# HARTING Product Change Notification

**PCN/21/007/C+N/US**

**Title:** Change to InduCom Hoods

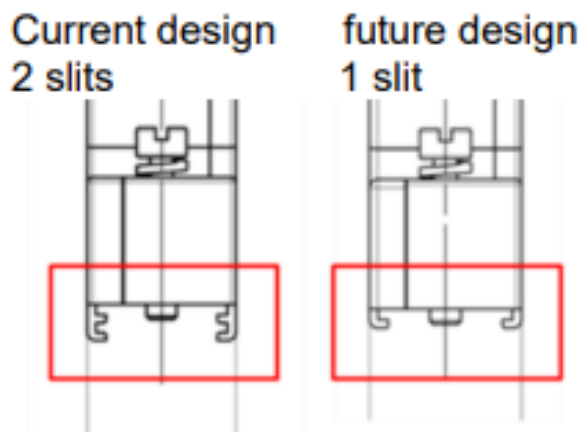
We have made a minor change to the Inducom hoods

At the end of 2019 HARTING changed the design of the Inducom hoods. At the outer side of the hoods a 2nd slit was added (see picture below). This slit was intended for use with a mechanical coding option to be launched in the future. Please be informed, that HARTING will eliminate this 2nd slit. With this change the overall length of the hoods will be reduced to the same dimension as the pre-2019 design

When the new coding system is introduced we will create separate part numbers for the corresponding hoods with two slits.
